# Site Plan Review

Site: 27300 Southfield Road  
Applicant: Abro Property Group  
Plan Date: January 23, 2024  
Zoning: MX Mixed Use District  
Parcel ID: 24-13-353-001  
Proposal: Interior / Exterior Commercial Building Renovation

TOTAL FRONT ELEVATION	4105.8 SQ. FT. = 100%
CULTURED STONE	367.76 SQ. FT. = 8%
GLASS	1490.37 SQ. FT. = 36.2%
FIBER CEMENT SIDING	1509.03 SQ. FT. = 36.7%
METAL CAP	203.54 SQ.FT. = 4%
STUCCO CROWN	317.8 SQ. FT. = 7%
BRICK	217.3 SQ. FT. = 5%

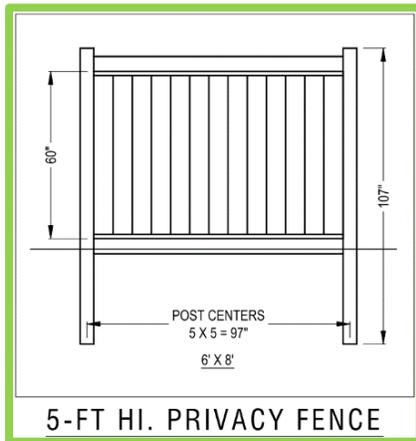
*Fiber cement siding is used among much of the façade that is not accented by brick or cultured stone. Fiber cement is a masonry product designed to replace traditional wood and vinyl elements, but due to the higher sustainability, it is often used in combination with or in place of traditional brick and stone. **The applicant may consider providing samples of the proposed materials for the Planning Commission to discuss with the applicant.***

*The Planning Commission may wish to discuss the appropriateness of the trim materials, particularly the stucco crowns in some areas.*

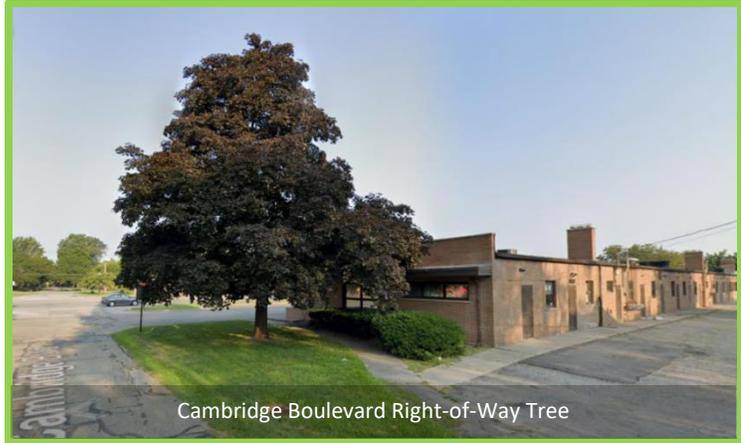
*A 10' x 40' loading zone is located along the northeast corner of the site and obstructs 3 of the 18 angled parking spaces along the alley. As a result, 41 of the 44 parking spaces would be provided when the loading zone is occupied, and **the site would temporarily be short 3 spaces, or 7%. The applicant shall demonstrate how deliveries will be accommodated on the site.***
